TECHNISCHE MITTEILUNG TECHNICAL NOTE

2<u>01-2</u>0 Nr:2<u>05-6</u>, 206-1 301-30

Reinforcement of the elevator assembly guides.

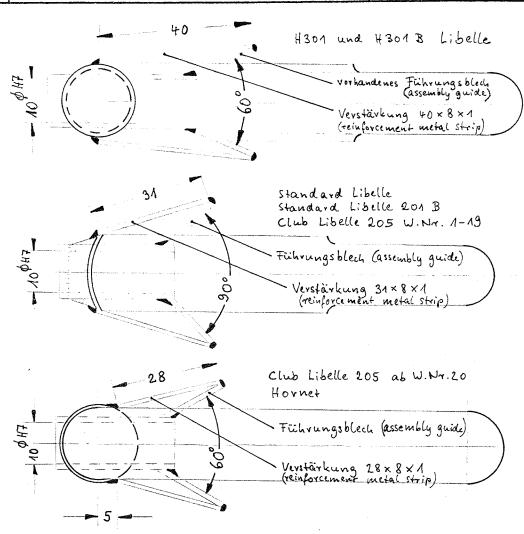
- 1. With a 5 x powered magnifier visually inspect the assembly guides for distortion, bending and/or for cracks in the welded seam.
- 2. If damage is found replace the bracket immediately with a bracket to be reinforced according to method 4.
- 3. If no damage is found replace the bracket with a bracket to be reinforced according to method 4 before the date quoted in "Urgency".
- 4. Weld in two sheet metal strips according to the following drawings to reinforce both guides. (see next page)

Sheet metal to specification 1.7214.4 or 1.7734.4, welding material to specification 1.7734.2 or 1.7324.0, welding process WIG (Wolfram-Inert-Gas). After removing the bracket insert a pin 10 mm Ø into the tube instead of the actuator pin to prevent warping during welding. It should be possible to insert this pin simply by hand. Remove the pin after the bracket has cooled down. Preserve the bracket again (recommended single component primer B 1742 from Lackfabrik Bäder and nitro lacquer). Fit the bracket to the tailplane and pay attention to the 2 washers between bracket and ball bearings.
